PCN-20190111 TE0841-02-* SPI Flash Change

Company	Trenz Electronic GmbH
PCN Number	PCN-20190111
Title	TE0841-02-* SPI Flash Change
Subject	BOM change
Issue Date	2019-07-15

Locate Flash (U6) on top side of PCB:

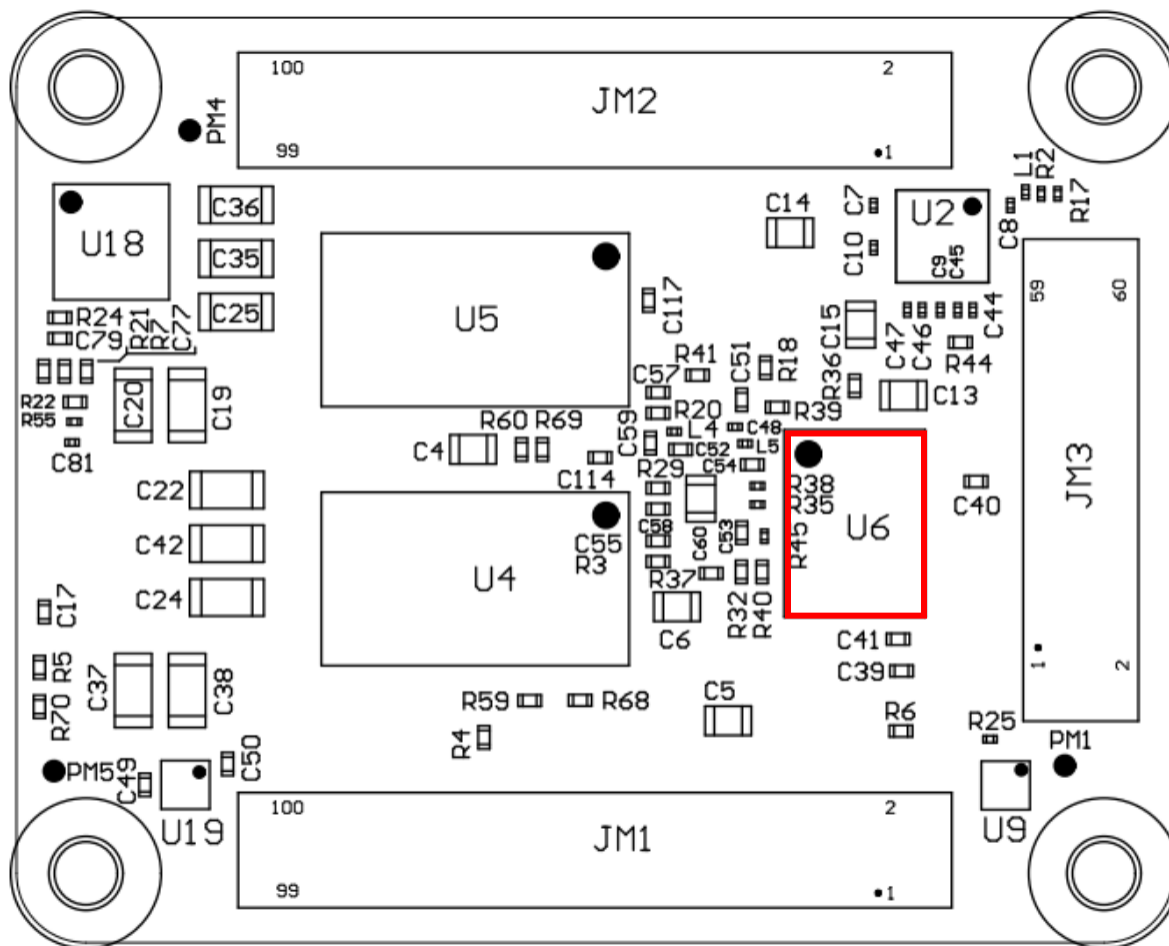
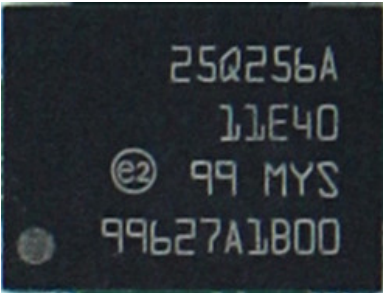
#1 Change SPI Flash from N25Q512A11G1240E to MT25QU512ABB8E12-0SIT

Reason: N25Q512A11G1240E became obsolete.

Impact: None. Both have same JEDEC ID BB20h and manufacturer ID 20h.

old	new
N25Q512A11G1240E	MT25QU512ABB8E12-0SIT
